From: Anna Williams
Sent: 11/02/2024 4:30:24 PM
To: Maxwell Duncan; Council Northernbeaches Mailbox
Cc: Jeff Annesley
Subject: TRIMMED: Submission objecting to DA 2023/1780 at 89 Marine Parade AVALON obo Jeff and Leonie Annesley
Attachments: Submission Annesley 89 Marine Parade Avalon.pdf;

RE: DA2023/1780 New Dwelling and swimming pool at 89 Marine Parade Avalon

Figure 2: Extent of Building Envelope breach outlined in red.

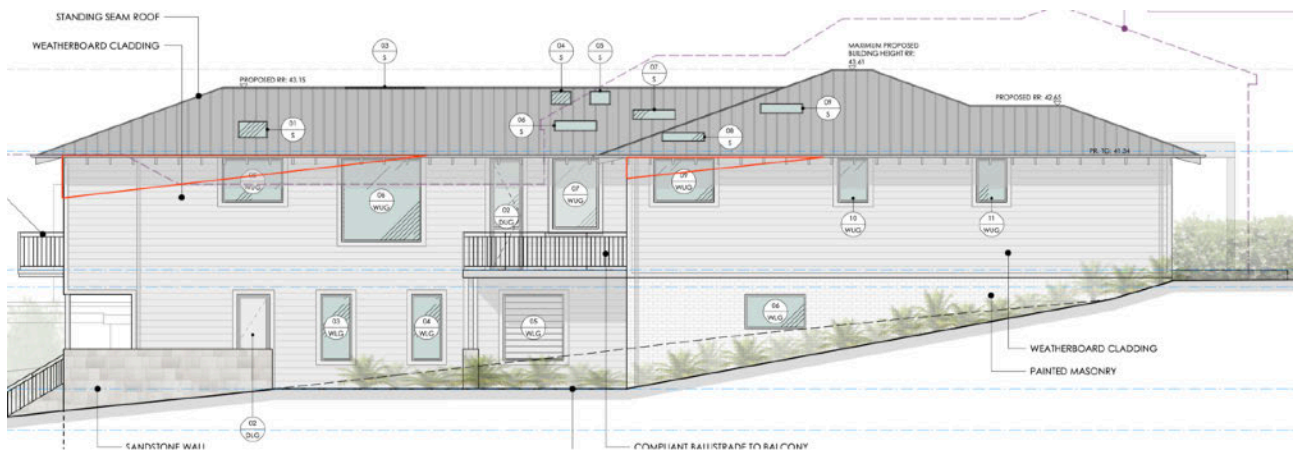
Notwithstanding the inaccurate diagrams, the elevating diagrams indicate a substantial increase in shadow from the proposed new dwelling. Overshadowing impacts will arise upon the private open space areas as a result of non-compliance with the building envelope control. The extent of the building that breaches this requirement is shown outlined in red below:

Impacts that arise from a non-compliance are less reasonable than in a development that complies. In this case, the variation to the building envelope control is not justified by either exceptions clause in the DCP, ie, the building footprint is not situated on a slope of over 30%, and the proposal is a new dwelling, not a first floor addition to an existing dwelling.

In addition, we note that the extensive excavation of the site proposed negates any construction difficulty posed by the fall of land along or across the site. Being a site of over 1000sqm and over 18m in width, there is no constraint that justifies the breach of the building envelope control, and therefore the impacts that arise.

We see that the floor to ceiling heights proposed for the new dwelling are excessive, in particular the basement level at 3.1m, and the upper ground level at 3.15m. These spaces have capacity for lower and yet very reasonable floor to ceiling heights of 2.7m, which would lower the overall height of the dwelling by up to 800mm. In doing so, the basement level would not change, and the upper ground level amenity would still be retained with the ability to maintain raked ceilings in the living areas.

As a minimum, the design should be amended to comply with the required building envelope. There is no justifiable reason why this cannot be achieved on a site with an area in excess of 1000sqm and a width of 18m+. Any design challenge relating to sloping land has been overcome entirely with the extensive excavation proposed and topographical conditions present no barrier to a complying development.
